DSO9064A-02

S E R V I C E N O T E

DSO9064A - 600MHz Digital Signal Oscilloscope

Repair for Windows “Power surge on hub” message

Situation:

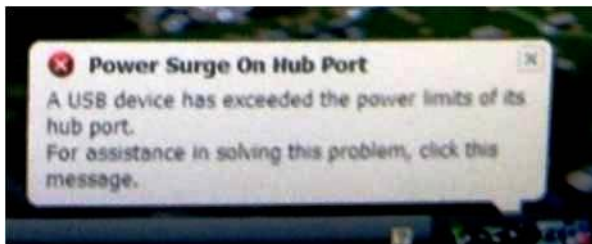
A few scopes display the below message. This upgrade kit installs three components which will resolve the problem and the message should disappear. If the message still appears, either the upgrade was done incorrectly or the motherboard is actually defective.

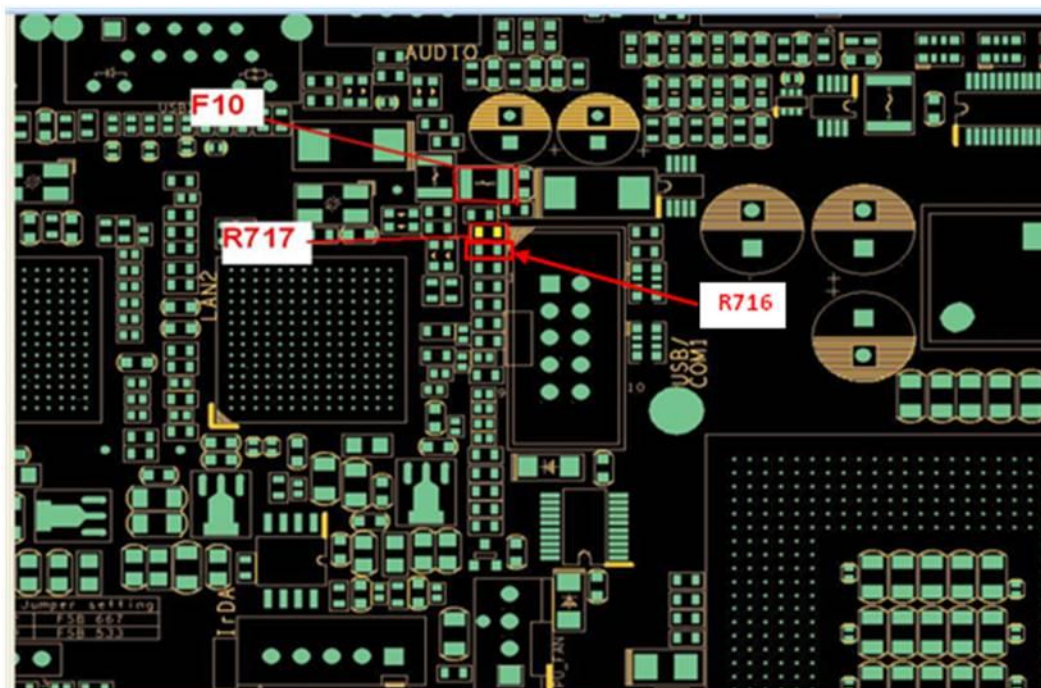
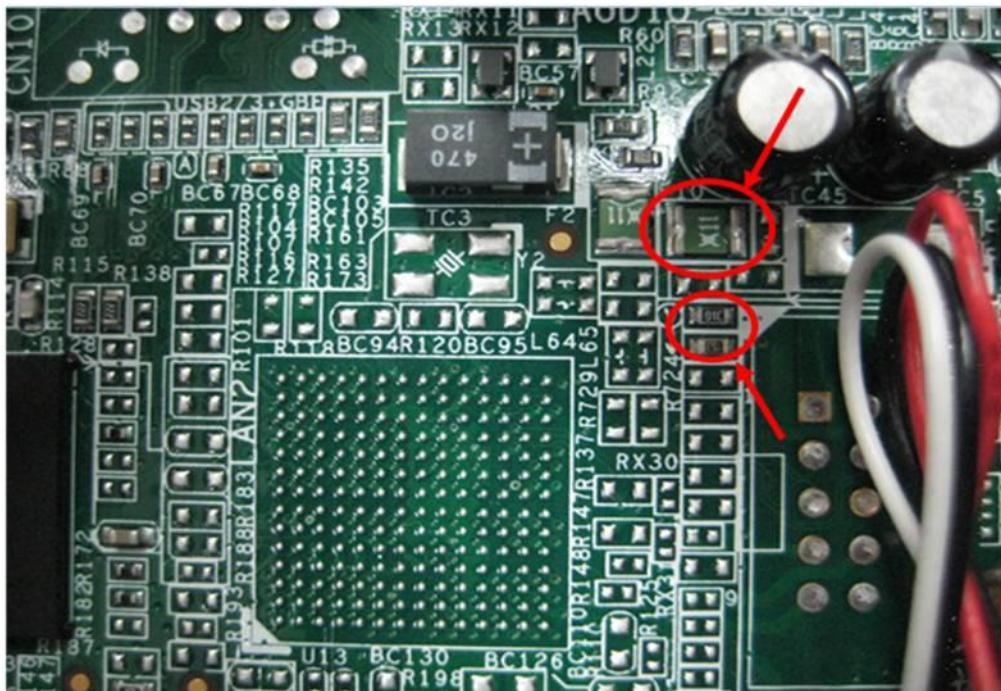
1. Refer to the service manual to remove the motherboard from the scope.
2. Install the three components from the upgrade kit on the motherboard. Refer to the below drawing and the drawing on the next page for component locations. The 0960-2789 motherboard is RoHS compliant and the below three components are also RoHS compliant. You should use a RoHS soldering station and RoHS solder techniques when possible.

F10 – 0837-3854 Thermistor

R717 – 0699-7654 10K Resistor

R716 – 0699-5789 15K resistor
